Access Compliance Report

Public Rights-of-Way

(Curb Ramps)

Intersection ID: 46698	Main Street: COFFEEBERRY_LN	Cross Street: TROTTERS_RIDGE_RD	Location: NW
ADA ID: D54C27E15E31	Ramp Type: PerpDiag	Initial Pass/Fail: Fail	Overall Compliance: No
Severity Score: 21.25			
Codes/Mitigation Info/Possible Solution		Field Measurements/Component Compliance

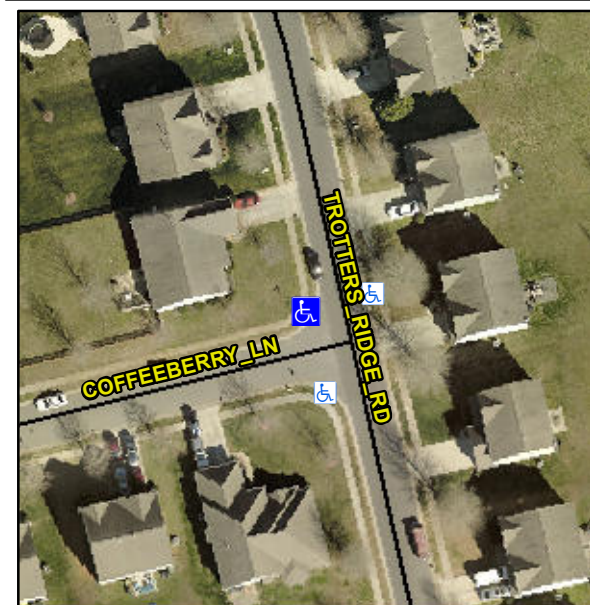
Not Found, R304.5.1, R304.2.2

Compliance	Description	Data	Compliance	Description	Data
N/A	Ramp Length (in)	43.5	No	Ramp Slope (%)	11.2
No	Ramp Width (in)	45.5	Yes	Ramp XSlope (%)	1.9
N/A	Flare Type LT	N/A	N/A	Flare Type RT	N/A
N/A	Flare Slope LT (%)	N/A	N/A	Flare Slope RT (%)	N/A
N/A	Flare Traversable LT?	N/A	N/A	Flare Traversable RT?	N/A
N/A	Landing Length (in)	N/A	N/A	DWS Provided?	N/A
N/A	Landing Width (in)	N/A	N/A	DWS Contrast?	N/A
N/A	Landing Slope (%)	N/A	N/A	DWS Length (in)	N/A
N/A	Landing X Slope (%)	N/A	N/A	DWS Full Width?	N/A
N/A	Landing Curb? (Y/N)	N/A	N/A	DWS Offset (in)	N/A
N/A	Shared Landing?	N/A			
N/A	Gutter Ponding?	N/A	N/A	Gutter Slope (%)	N/A
N/A	Gutter Lip Ht (in)	N/A	N/A	Gutter X Slope (%)	N/A
N/A	Painted X Walk1?	No	N/A	Painted X Walk2?	No
	X Walk 1 Direction	To S		X Walk 2 Direction	To E
N/A	X Walk 1 Width (in)	N/A	N/A	X Walk 2 Width (in)	N/A
	X Walk 1 Slope (%)	0.5		X Walk 2 Slope (%)	3.4
	X Walk 1 X Slope (%)	1.8		X Walk 2 X Slope (%)	0.6

Remove & Replace Curb Ramp With Two New Directional Ramps or Equivalent.
